October 19, 2025

RE: Mission Ridge Master Planned Resort Expansion
Draft Environmental Impact Statement Concerns

Project location map from revised site plans showing proximity of Forest Ridge to the project

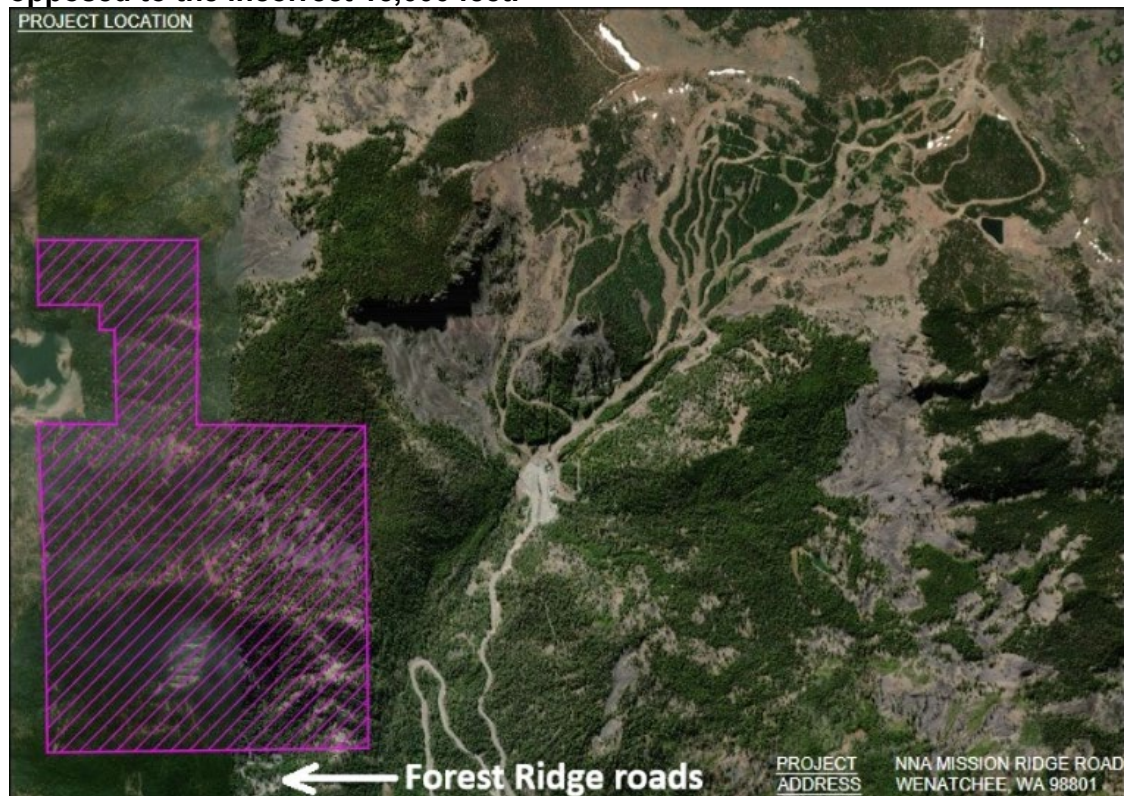
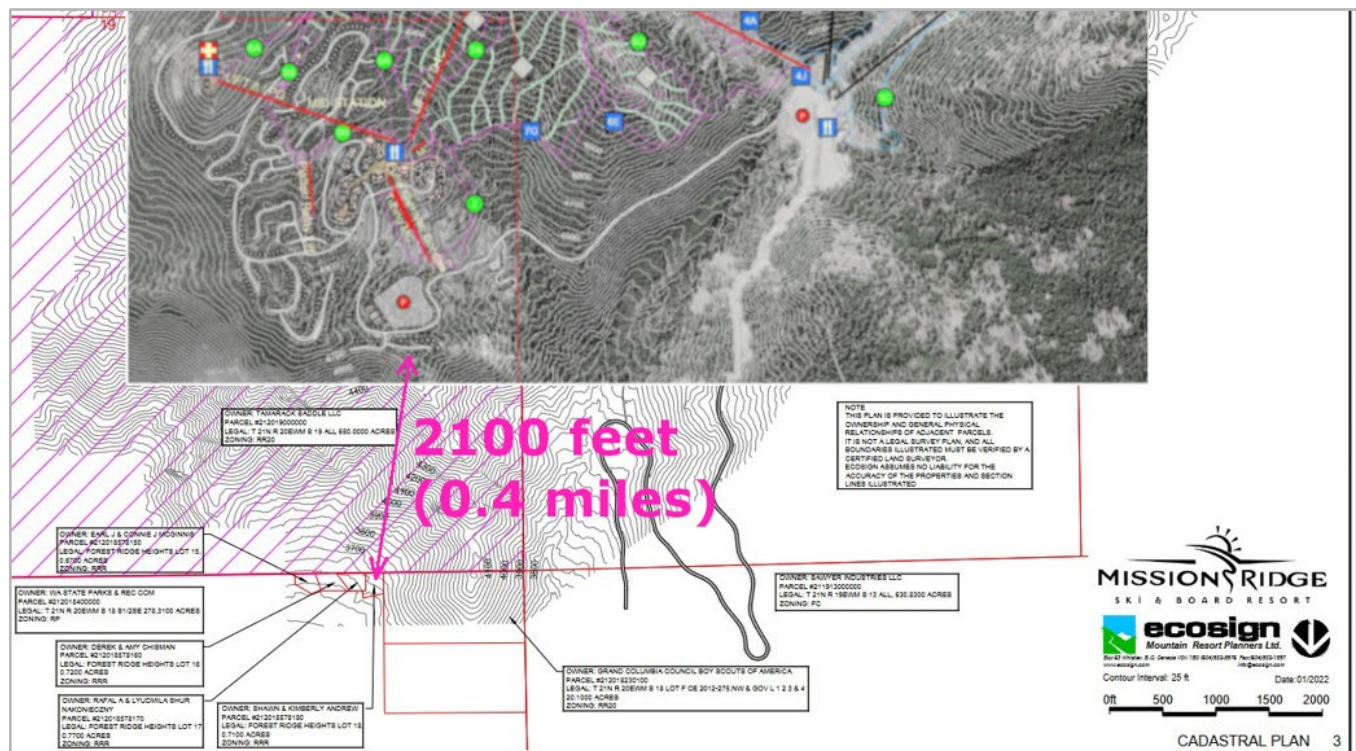
"Residences in the Forest Ridge neighborhood are more than 3 miles north of the proposed resort construction,"

This is not correct. The nearest Forest Ridge homes are roughly 0.4 miles from the development homes. The relationship between the nearest Forrest Ridge homes to the nearest proposed development homes is shown on the graphics below which are reproduced and edited from the [revised site plans](#) submitted to Chelan County in 2022. 15,000 feet is used in sound level discussion throughout the chapter. This number is erroneous and relates to the incorrect 3 mile assertion. **The DEIS should**

be revised to correct the proximity of Forest Ridge to the project from “more than 3 miles” to roughly 0.4 miles. The sound discussions should be updated to reflect the correct 2100 feet as opposed to the incorrect 15,000 feet.
